ADDENDUM
NO. 2

April 20, 2021

HANOVER CENTRAL HIGH SCHOOL ADDITIONS AND RENOVATIONS
Cedar Lake, IN 46303

Addendum Two (AD.02) to the drawings and specifications prepared by Gibraltar Design and The Skillman Corporation for **Hanover High School Addition and Renovations** for Hanover Community School Corporation, Cedar Lake, Indiana.

SHEET M-201

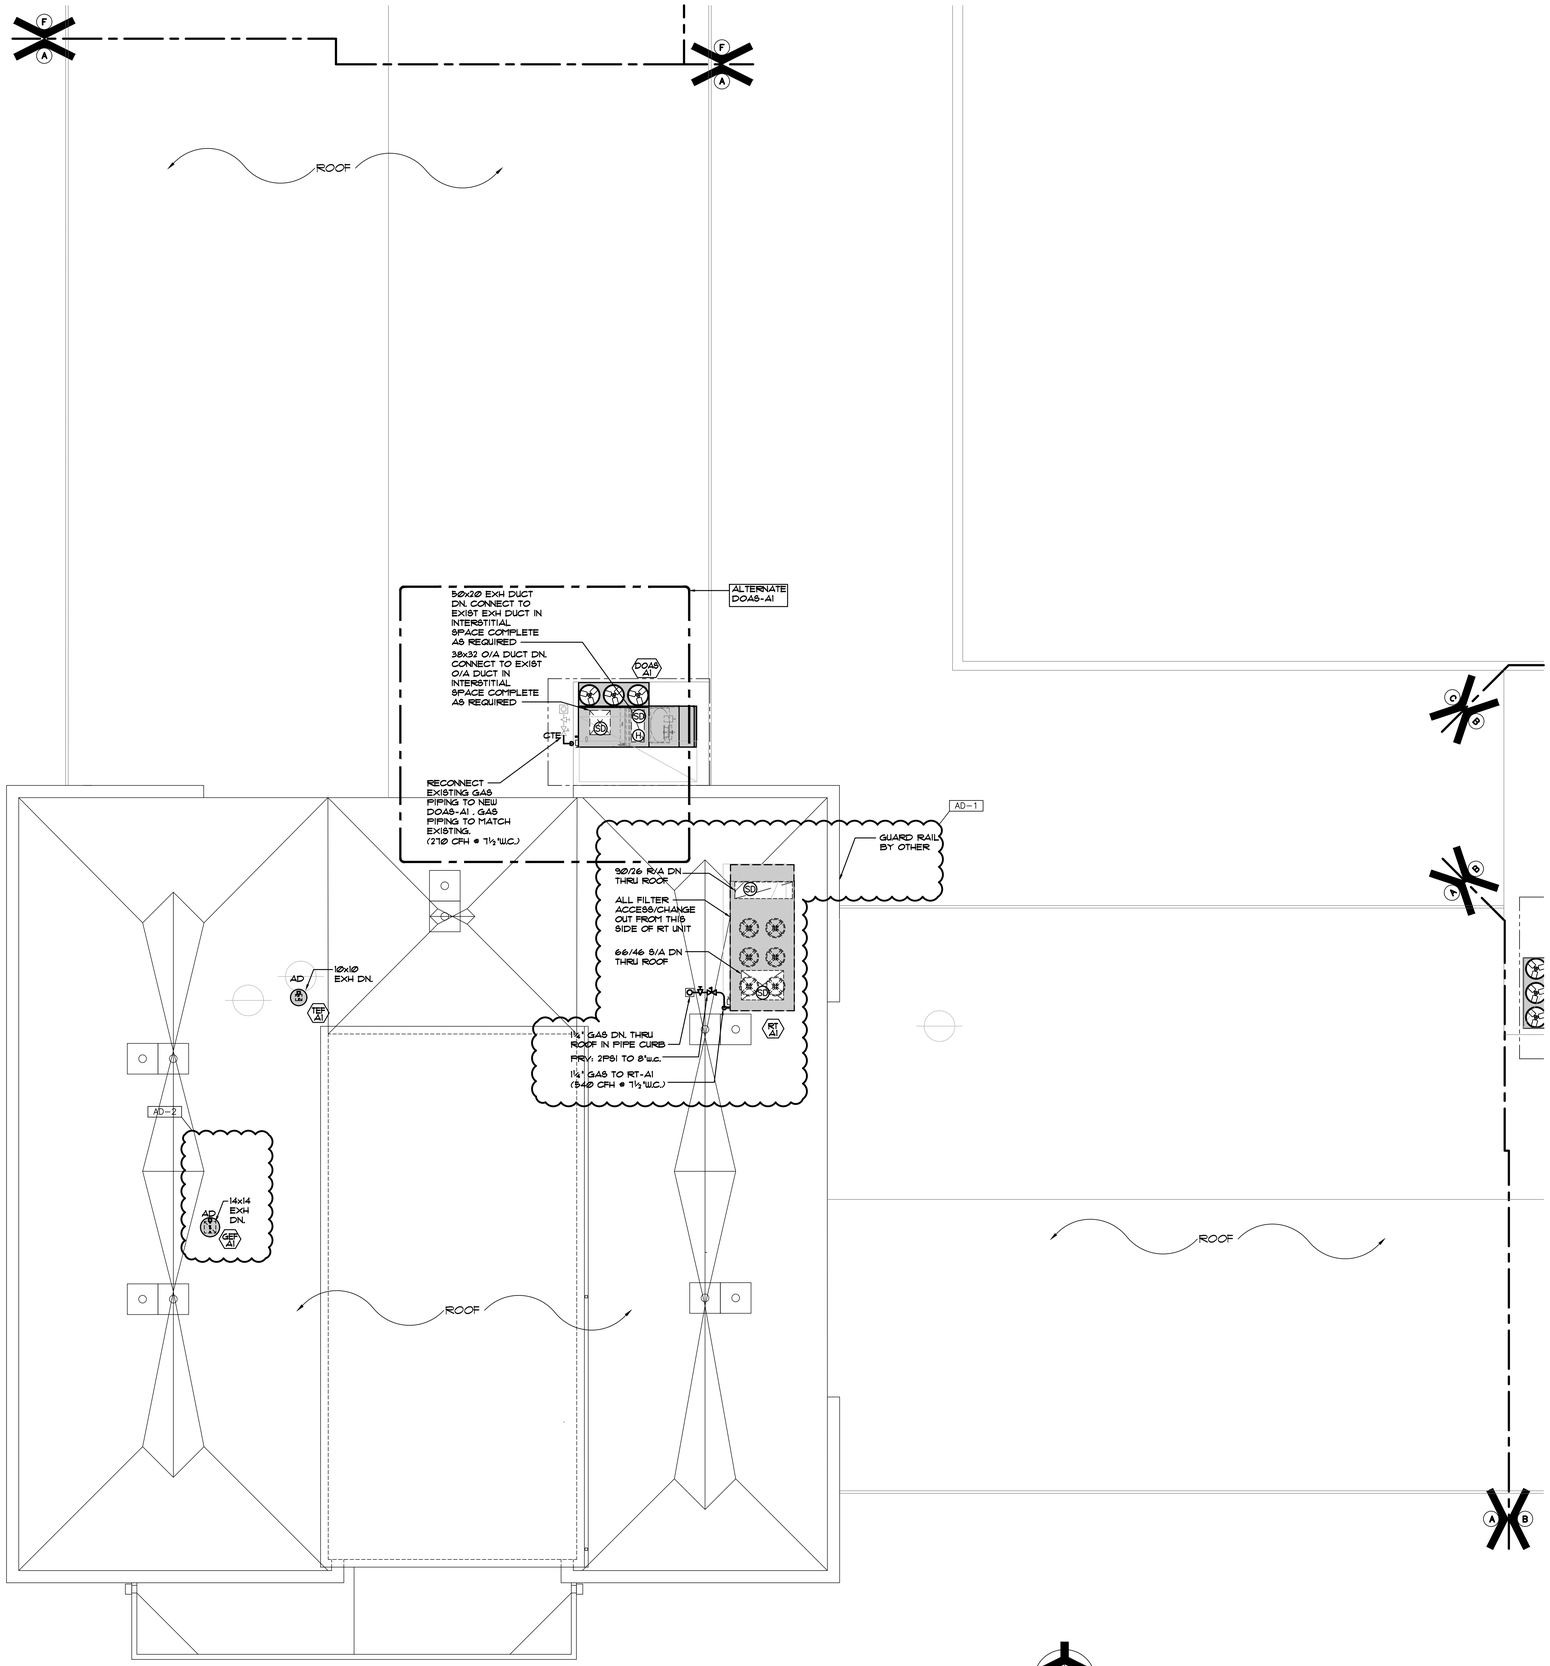
45. Sheet M-201

A. Refer to revised full-size drawing, included in this Addendum, for the following revisions:

SHEET M-206

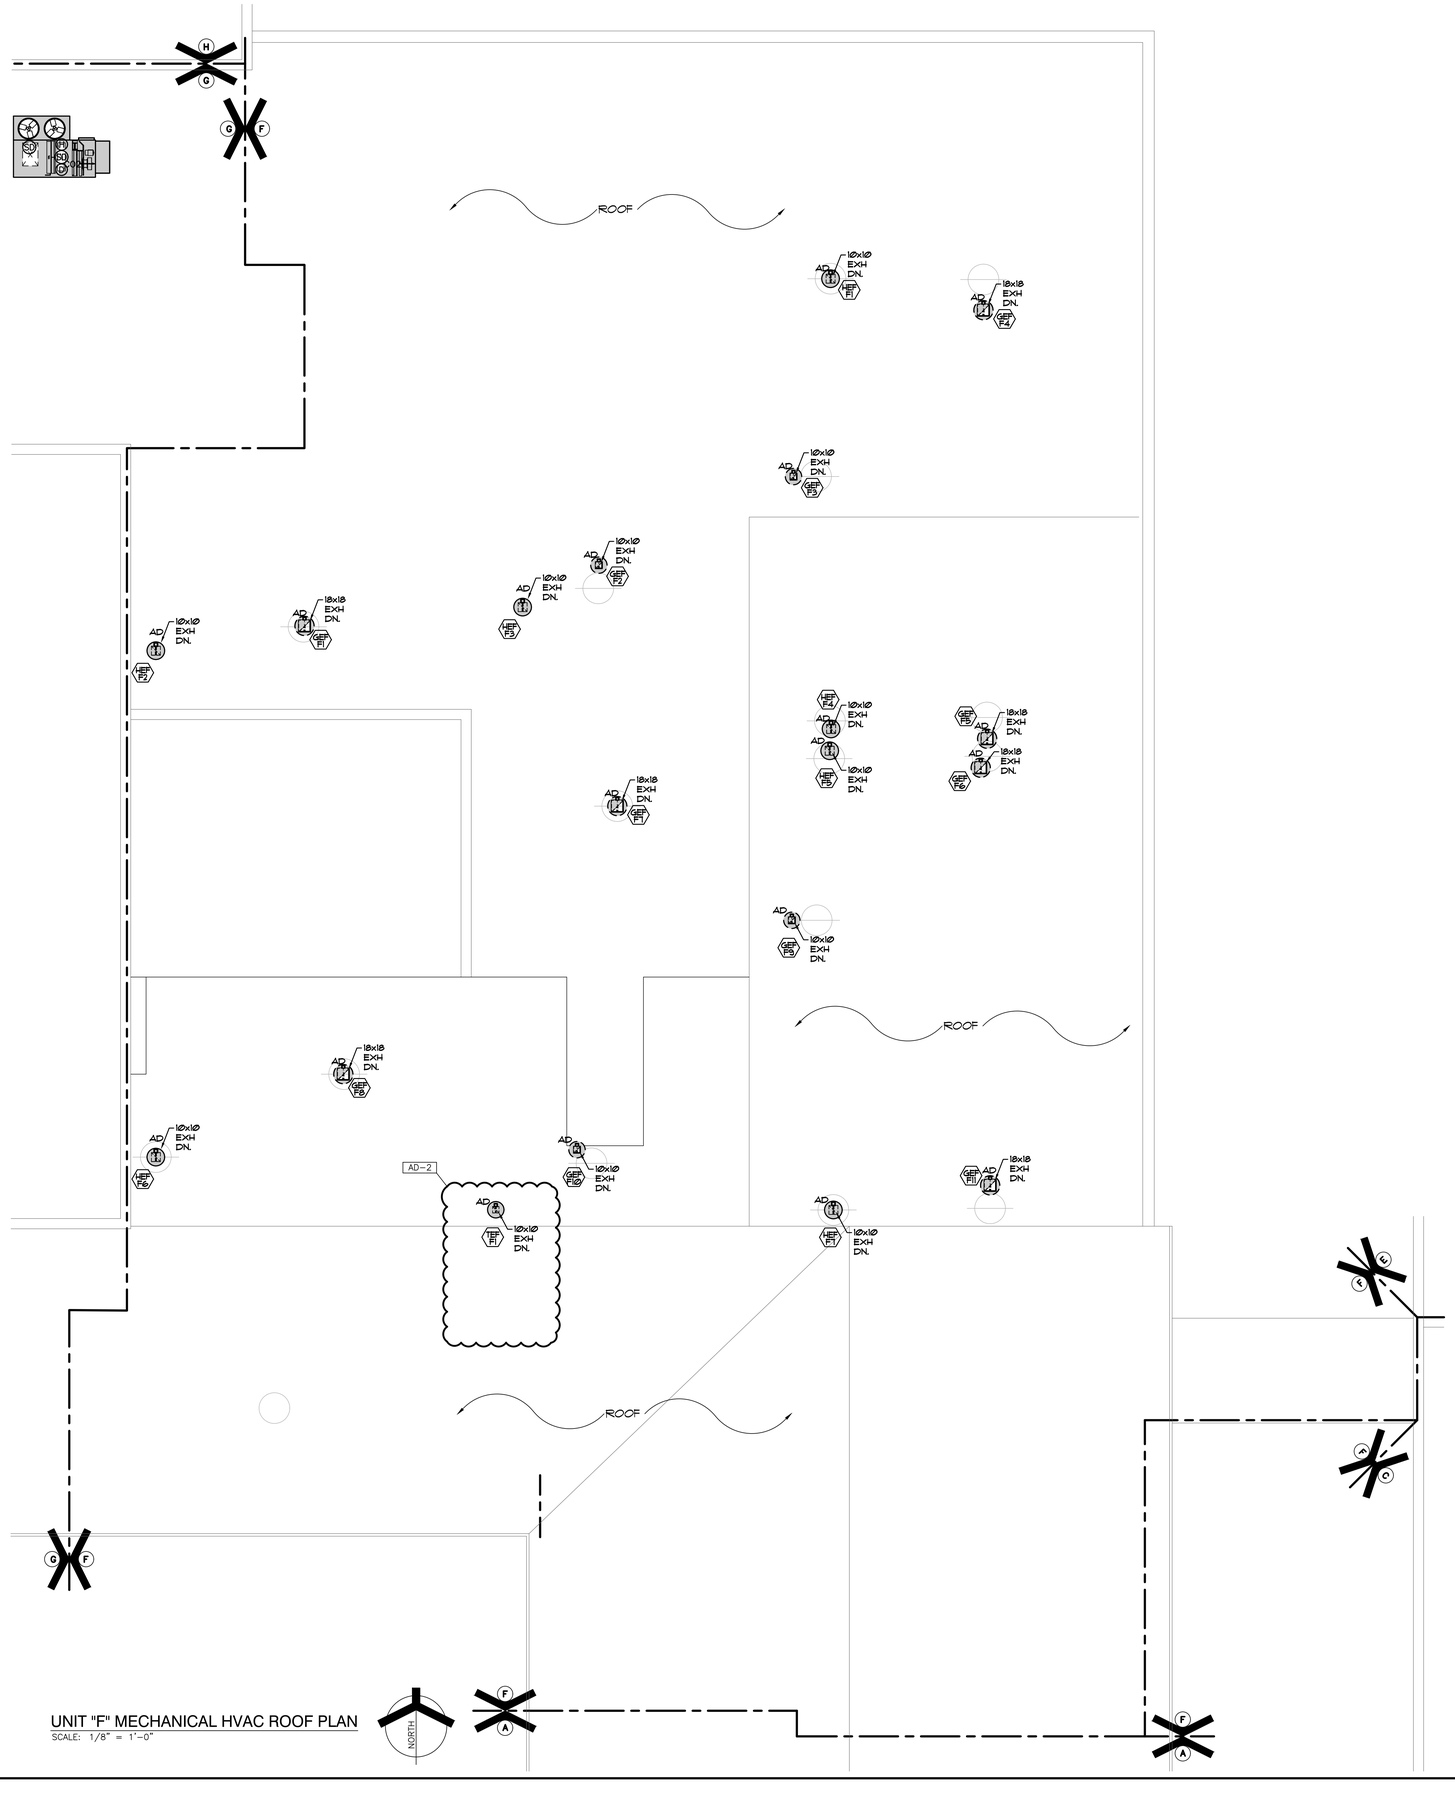
46. Sheet M-206

A. Refer to revised full-size drawing, included in this Addendum, for the following revisions:

SHEET P-111

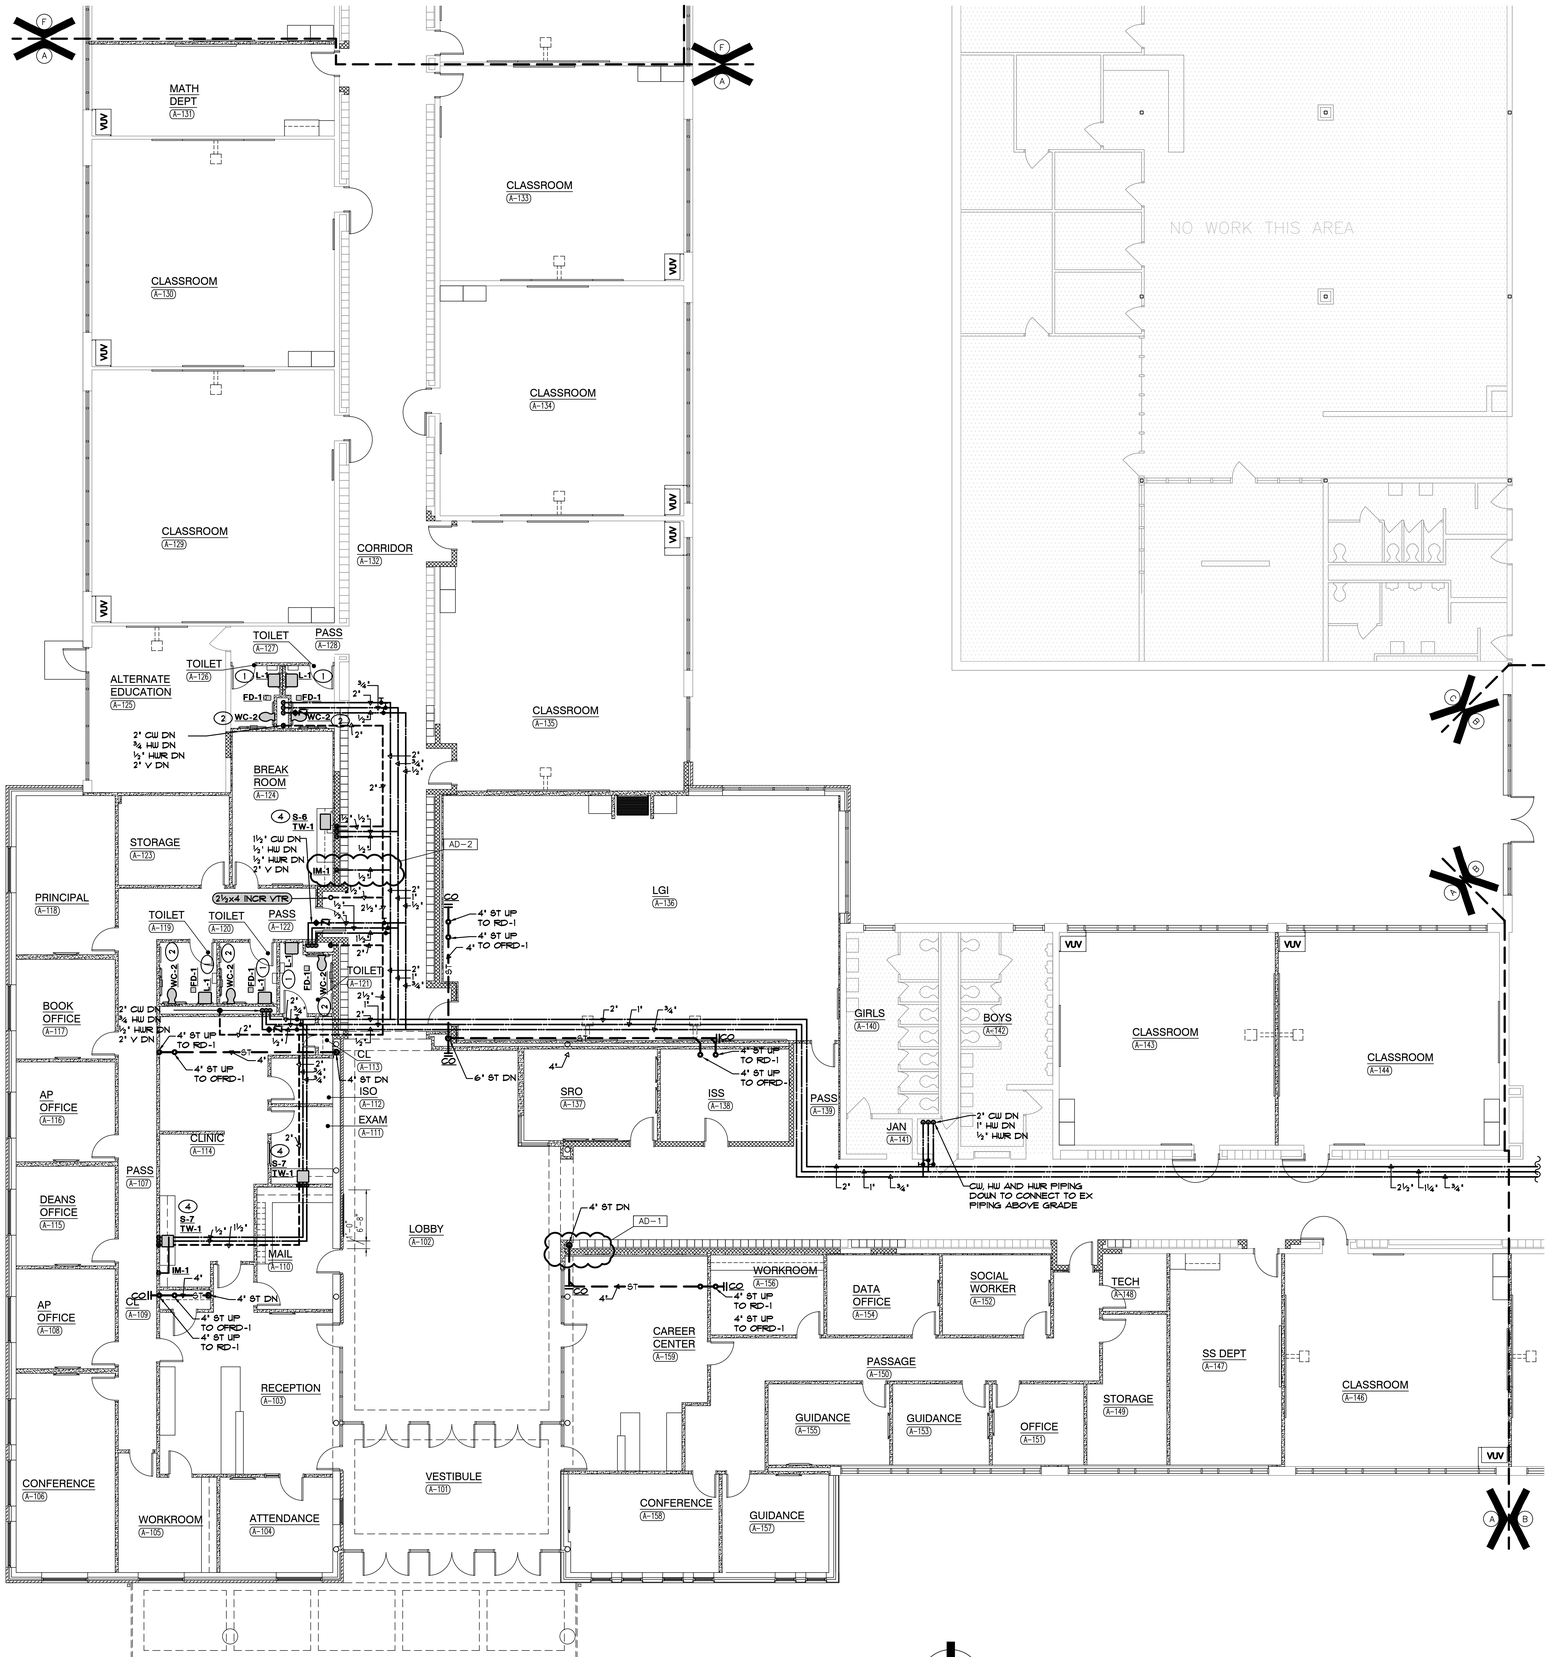
53. Sheet P-111

A. Refer to revised full-size drawing, included in this Addendum, for the following revisions:

1. Added ice maker in Break room a-124.

SHEET P-115

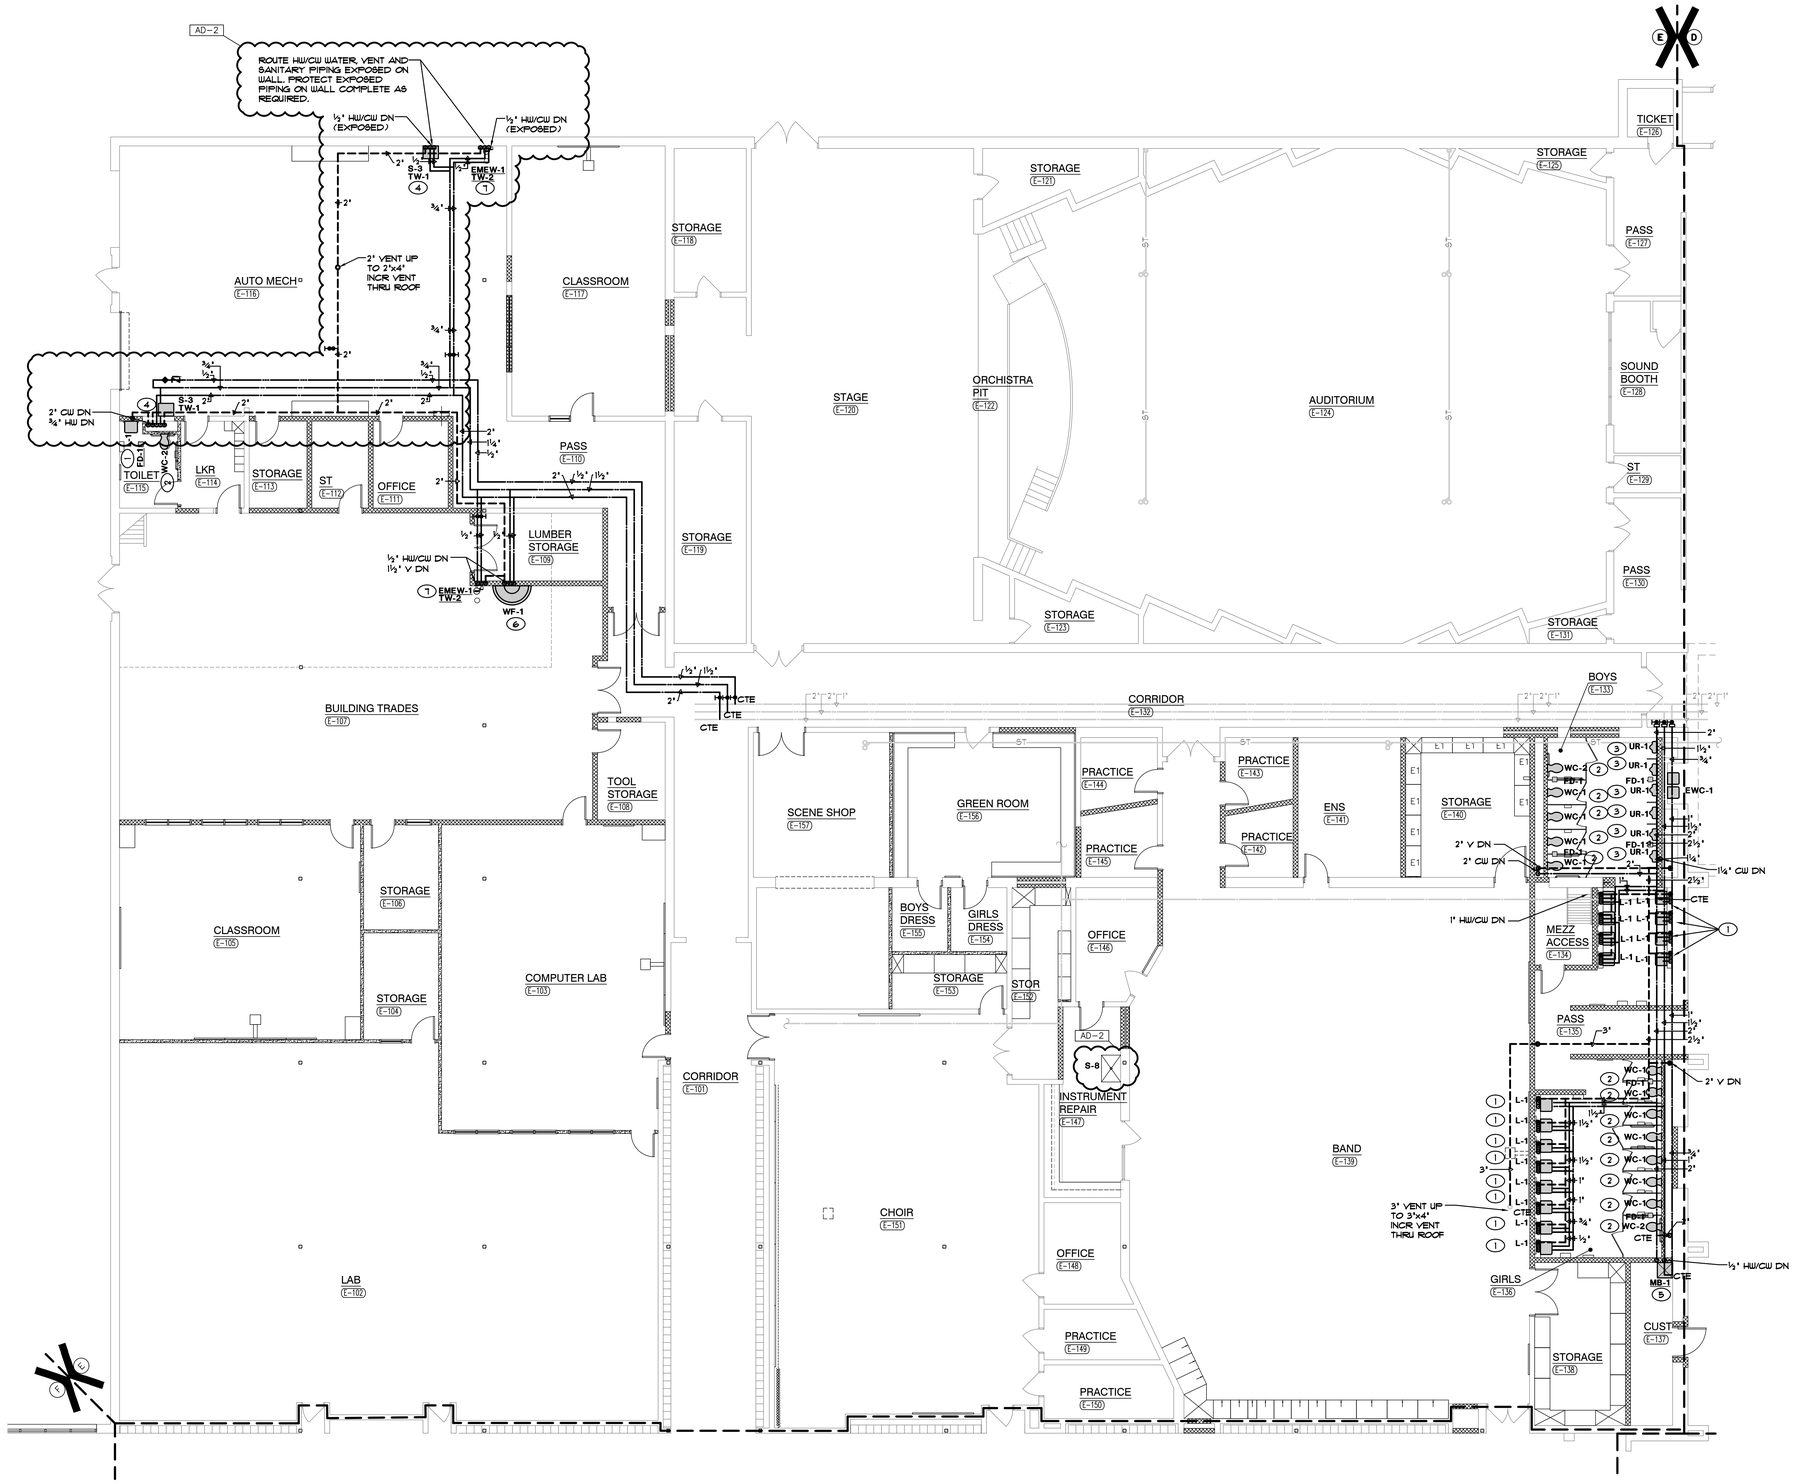
55. Sheet P-115

A. Refer to revised full-size drawing, included in this Addendum, for the following revisions:
